Charlotte-Mecklenburg Planning, Design, & Development

SUBJECT: Administrative Approval for Petition No. 2020-060 Westplan Investors

ACCENT BERKELEY PLACE
REZONING PLAN
PETITION 2020-060
BERKELEY PLACE DRIVE
CHARLOTTE, NORTH CAROLINA

REZONING PLAN

RZ-1

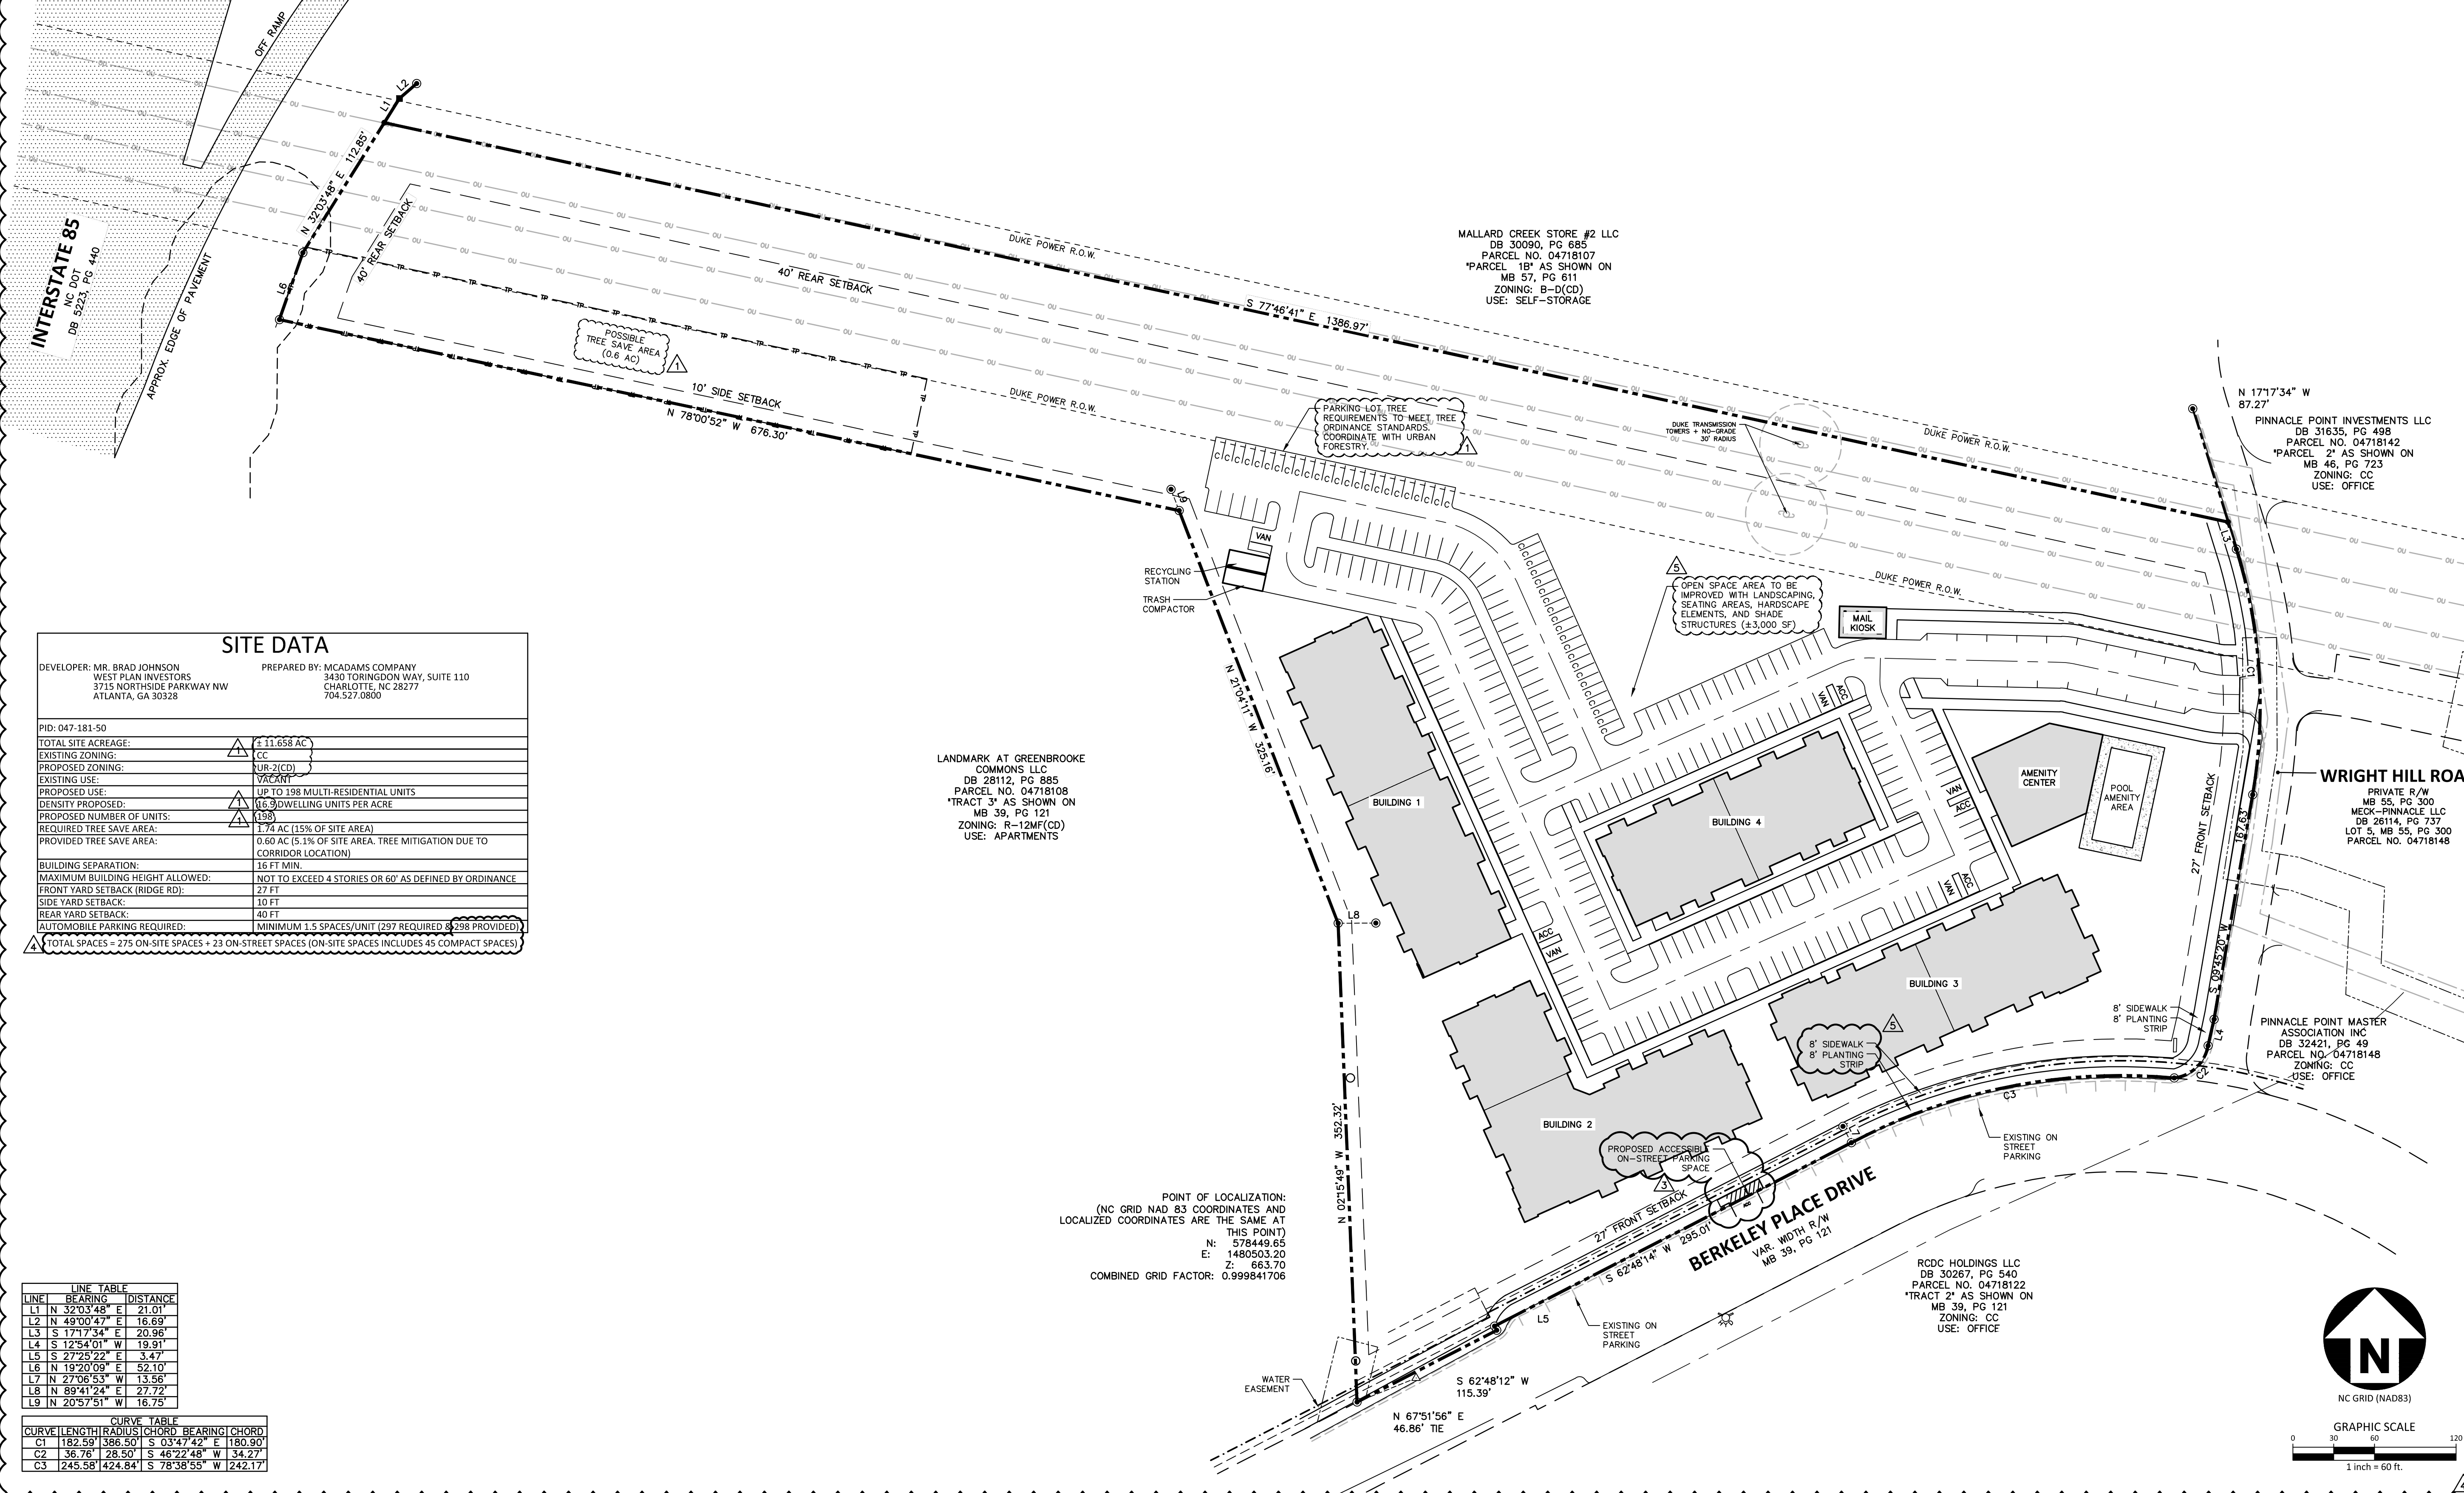
- To allow the removal of a driveway connection.
- To allow a modification to the site layout.

- The site plan complies with the conditional notes and still meets the intent of the original approval by the City Council.
